St. Lucie Units 1 and 2
Docket Nos. 50-335 and 50-389

Florida Power & Light/St. Lucie's Response To Request For Additional Information Regarding Overall Integrated Plan In Response To Order EA-12-051, "Reliable Spent Fuel Pool Instrumentation"

Response to Request for Additional Information Regarding Overall Integrated Plan in Response to Order EA-12-051

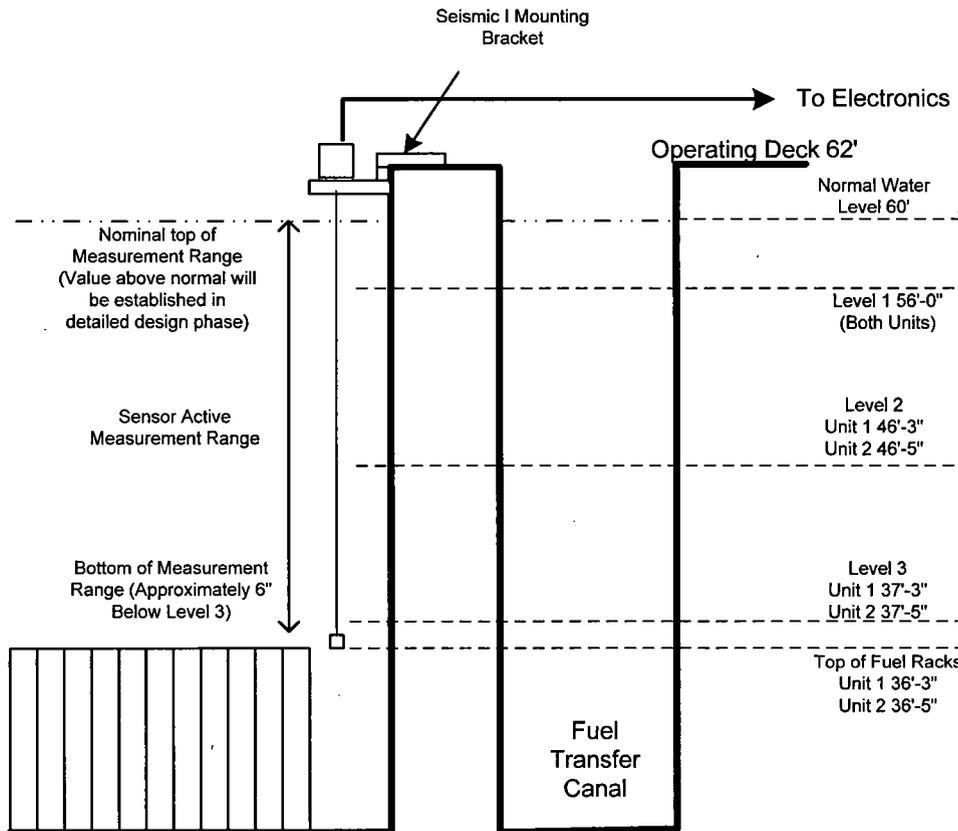
- a) *For level 1, specify how the identified location represents the HIGHER of the two
points described in the NEI 12-02 guidance for this level.*
- b) *A clearly labeled sketch depicting the elevation view of the proposed typical
mounting arrangement for the portions of instrument channel consisting of
permanent measurement channel equipment (e.g., fixed level sensors and/or
stilling wells, and mounting brackets). Indicate on this sketch the datum values*

representing Level 1, Level 2, and Level 3 as well as the top of the fuel racks. Indicate on this sketch the portion of the level sensor measurement range that is sensitive to measurement of the fuel pool level, with respect to the Level 1, Level 2, and Level 3 datum points.

The following sketch contains the information requested in RAI-1.b. Instrument uncertainty, which is to be determined, is not included in the elevation values for Levels 1 and 3.

Note that FPL is modifying the previously provided elevation for Level 3 based on subsequent industry and regulatory discussions that have occurred since submittal of the OIP.

Accordingly, the previous Level 3 elevation of 36'-3" for St. Lucie Unit 1 is being revised to 37'-3" and 36'-5" for St. Lucie Unit 2 is being revised to 37'-5".
